TENNESSEE VALLEY AUTHORITY

WATTS BAR NUCLEAR PLANT
NRC QUESTIONS OF AUGUST 14, 1984

ENCLOSURE 2
WATTS BAR NUCLEAR PLANT
10 CFR 50 APPENDIX R DEVIATION REQUESTS

UL established Project 84NK26564 to conduct the investigation described in UL's letter dated October 12, 1984 to review the installation of doors and frames installed in Watts Bar Nuclear Power Station.

FILE
NC777-1
ILL 1

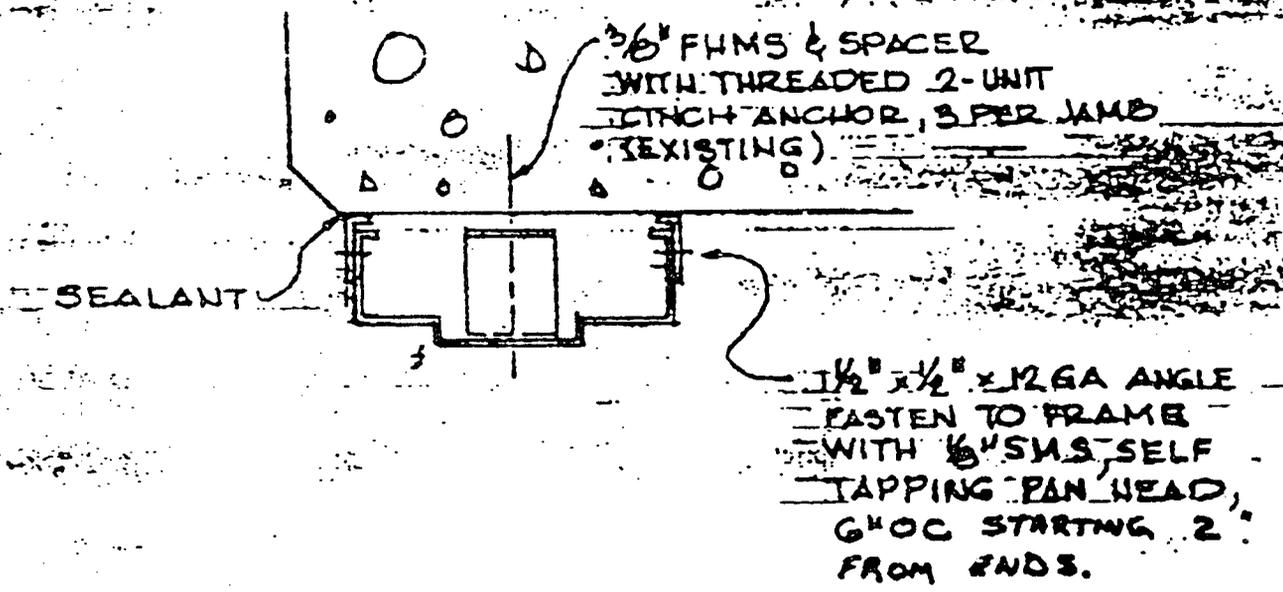
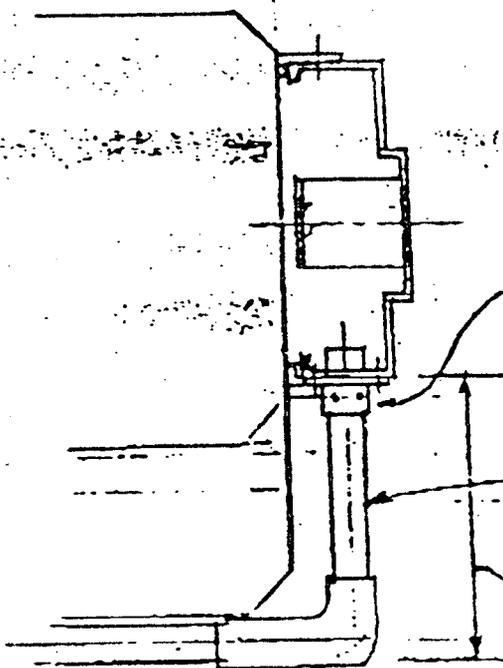
12. With regard to the installation of the existing opening fire door frames, NFPA 80, PAR. 2-3 requires that "Frames shall be securely anchored to the wall construction." The installation of the frames with approximately a 1/4 in. gap around the perimeter of the frame between the frame and the masonry wall may not meet this intent. Two adverse conditions may develop under fire situations.

1. Since the frame is not tight against the wall, it may not be prevented from rotating around its vertical axis when subjected to fire. The "caulk" not being a permanent, incompressible material cannot be considered capable of holding the frame in position. If the frame does twist, the strike may twist away from the latch bolt, allowing the latch to become disengaged and the door to swing open.
2. The amount of "caulk" sealing the opening from one side of the frame to the other may not act as an effective fire barrier. The materials, generally known as "caulk", normally do not resist the action of high temperature. Even seal materials which are intended for use at high temperatures may not have sufficient structural integrity to prevent the passage of fire when the fire undergoes great temperature changes.

Normally frames for existing openings are drawn tight at both the head and both jambs. A high temperature seal material is then applied around the perimeter of the frame where it meets the wall to seal off very small openings which may be present due to slight irregularities in the wall construction.

It is judged that the alternate installation shown on the attached ILL. 1 would be acceptable provided:

1. The frames have steel shims between the anchor reinforcement and the wall.
2. The head of the frames are constructed as shown for the jambs.

FILE
SK777-1
ILL 2

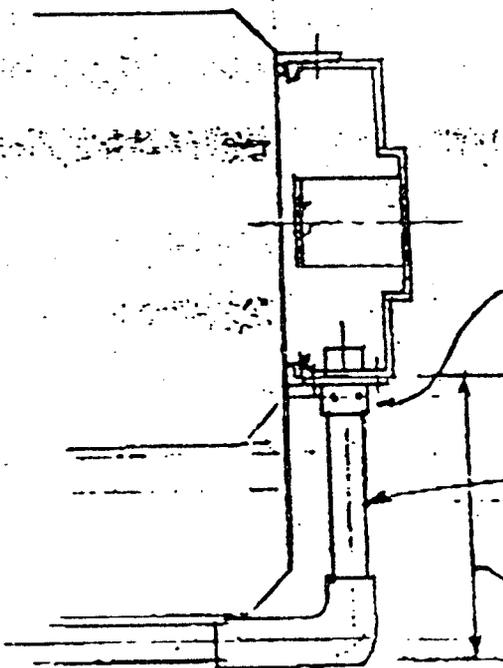
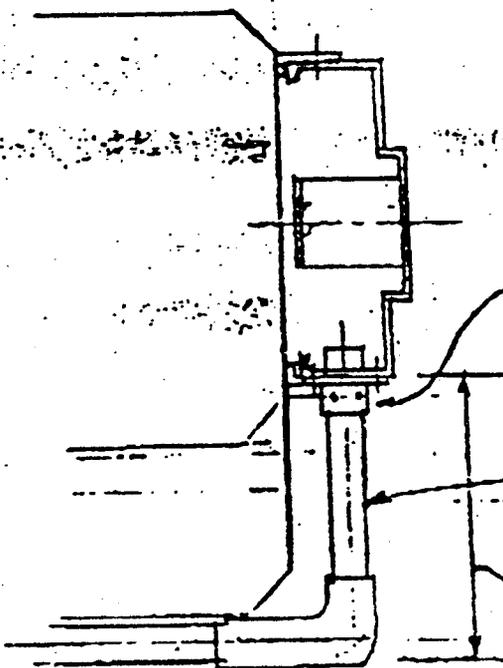
4. Conduit Penetrations - Several of the frames were provided with electrical conduit penetrations.

The installation of conduit to one side of a door frame with the proper fitting and conduit penetration protection, as shown by ILL. 2, is judged not to adversely affect the performance of the frame assembly under fire conditions.

As an alternate to protecting the complete throat of the frame adjacent to the penetration continuously welding the fitting to the frame and then protecting the inside of the conduit is judged not to adversely affect the performance of the frame assembly under fire conditions.

WHERE CONDUIT IS NOT SECURED TO FRAME MOUNT A SPLIT SLEEVE WITH 3/8" SCREW INTO FRAME AND CONDUIT FASTENING CONDUIT SECURELY TO FRAME

WHERE CONDULET EXIST - REMOVE BLANK COVER AND FILL CONDUIT WITH RTV 800 SEALANT BY GENERAL ELECTRIC. IN OTHER AREAS REMOVE CONDUIT JOINT AND INSTALL RTV SEALANT
